RECOMMENDED SERVICE BULLETIN NO. RSB40-011/1

SUPERSEDES SERVICE BULLETIN NO. RSB40-011

Starter relay.

„STARTER RELAY INSTALLATION“

DA4-2466-10-00"b"

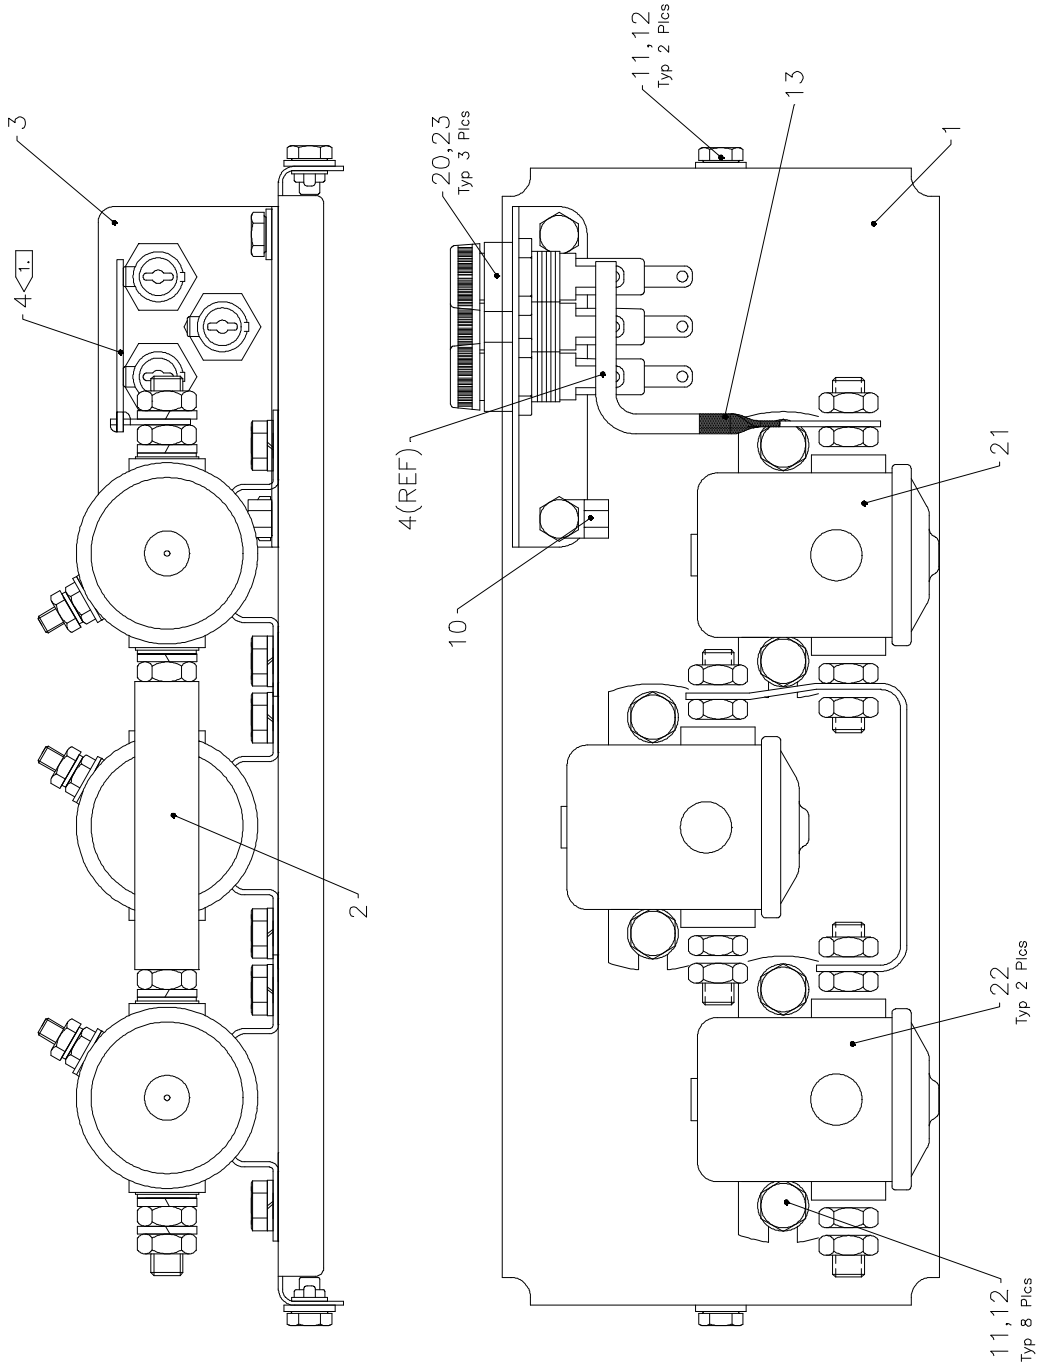
1	Remove upper cowling
2	Disconnect battery (negative pole first)
3	Release relay box cover
4	Disconnect cables
5	Remove starter cable (no. 80104 A4)
6	Remove the complete relay panel (item 1, dwg. no. DA4-2466-10-00"b")
7	Remove bus bar and hot battery bus (items 2 and 4, dwg. no. DA4-2466-10-00"b")
8	Release all three relays
9	Release fuse holders (items 20, dwg. no. DA4-2466-10-00"b") from the fuse holder bracket (item 3, dwg. no. DA4-2466-10-00"b")
10	Remove fuse holder bracket (item 3, dwg. no. DA4-2466-10-00"b")
11	Install new starter cable part # 17.6011 in accordance with the Airplane Maintenance Manual Doc No. 6.02.01
12	Install spacer part # 17.6015 with C.S. Bolts part # MS24693-S274, Lock Nut part # MS21044N3 and washer part # 11.5210 on Kissling relay part # 17.6002 (items 5, 7, 9, 12, 24, dwg. no. DA4-2466-10-00"d")
13	Install EPU relay (S-1577A1) and battery relay (S-1580A1) (items 22 and 21, dwg. no. DA4-2466-10-00"d") on new relay panel part # 17.6020

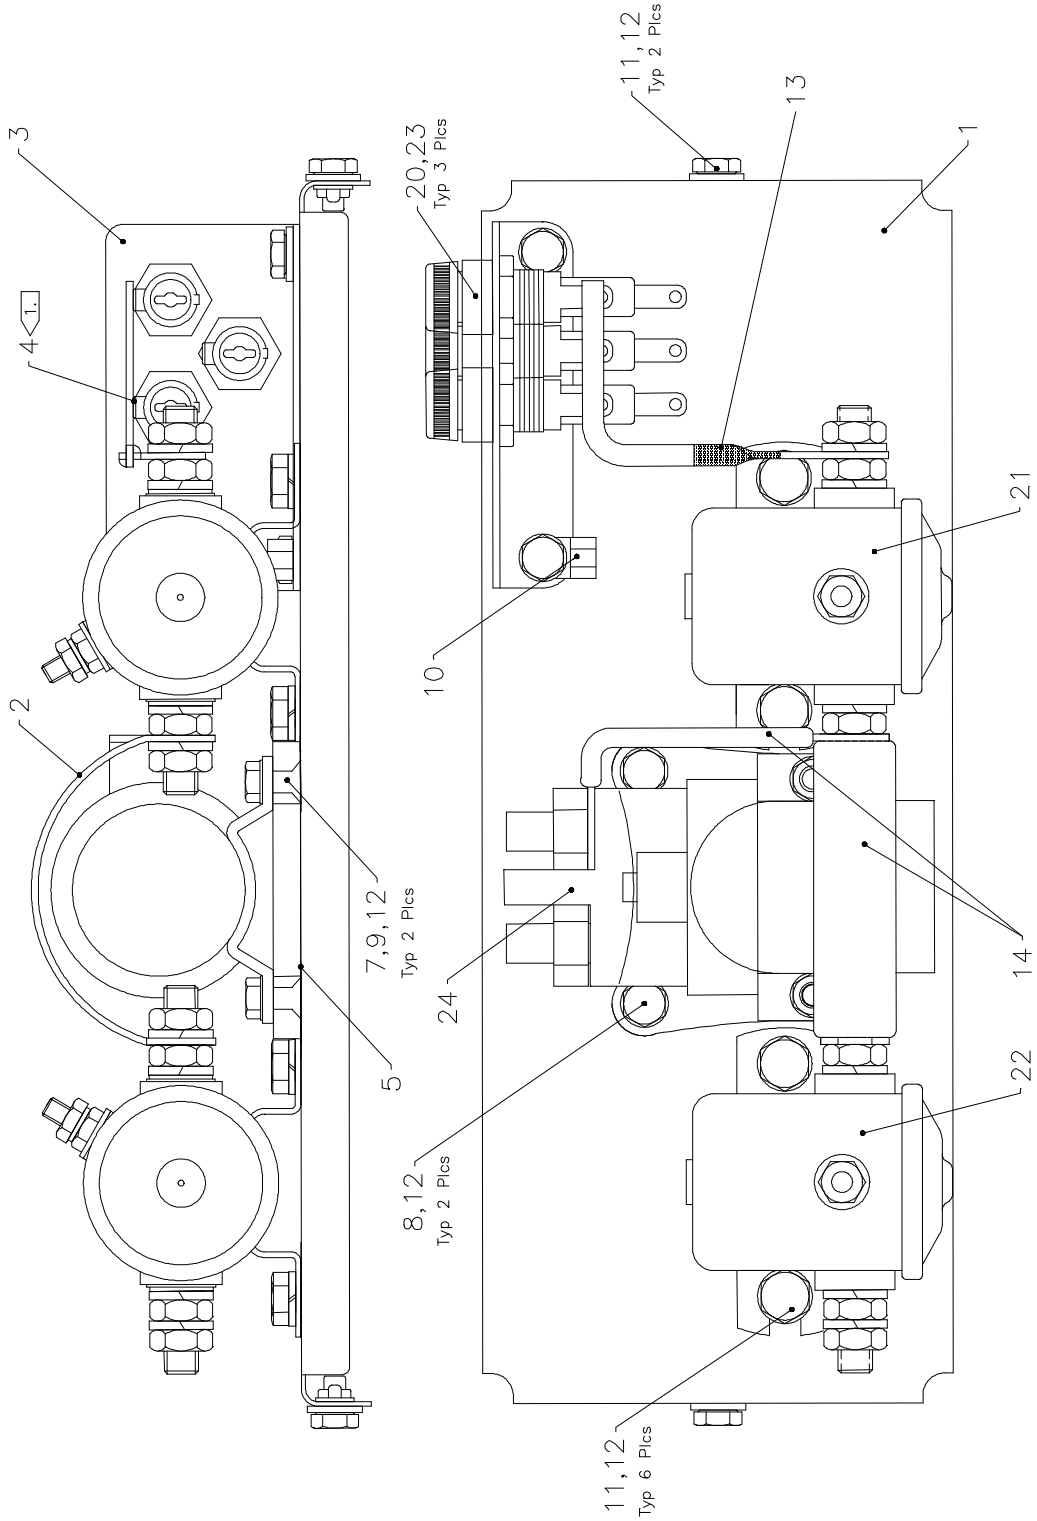
17	Install Kissling starter relay part # 17.6002 (item 24, dwg. no. DA4-2466-10-00"d") on new relay panel part # 17.6020 with bolts part # 11.5300 (item 8, dwg. no. DA4-2466-10-00"d") and washers and connect the ground cable in accordance with dwg. no. DA4-2406-30-00a
18	Install bus bar part # 17.6017 with heat shrinks part # 17.0854 (items 2 and 14, dwg. no. DA4-2466-10-00"d")
19	Install fuse holder bracket part # 17.6010 (item 3, dwg. no. DA4-2466-10-00"d")
20	Install fuses and fuse holders (items 20 and 23, dwg. no. DA4-2466-10-00"d")
21	Install hot battery bus part # 17.6016 and heat shrink part # 17.0851 (items 4 and 13, dwg. no. DA4-2466-10-00"d"). Solder bus to fuse tab
22	Install assembled relay panel
23	Connect cables
24	Check for foreign objects
25	Ensure a tight fit of all parts
26	Install the new relay box cover part # 40.1530
27	Connect battery
28	Install upper cowling

DA4-2406-30-00"a"

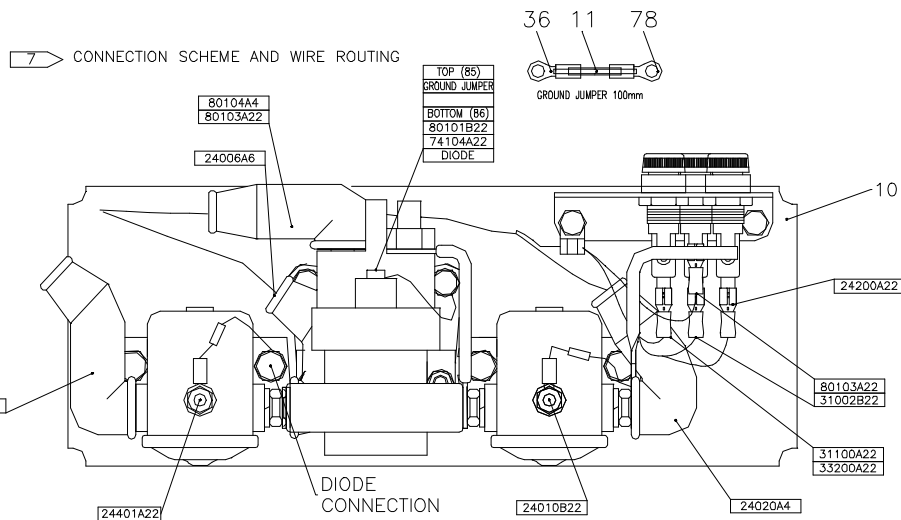
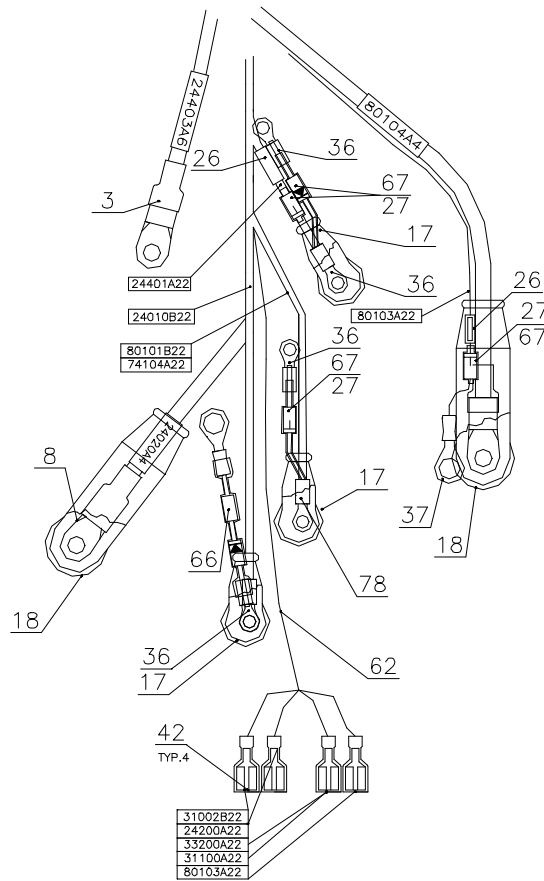
14	Build ground cable from ring terminals 17.6018, 17.6019 and wire 17.1590 in accordance with dwg. no. DA4-2406-30-00"a" (items 36, 11, 78)
15	Install new ring terminals part # 17.6022 (item 37, dwg. no. DA4-2406-30-00"a") on wire # 80103A22 and part # 17.6019 (item 78, dwg. no. DA4-2406-30-00"a") on wire # 80101B22/74104A22/ Diode)
16	Install ground cable on the starter relay connection 85 in accordance with dwg. no. DA4-2406-30-00"a"
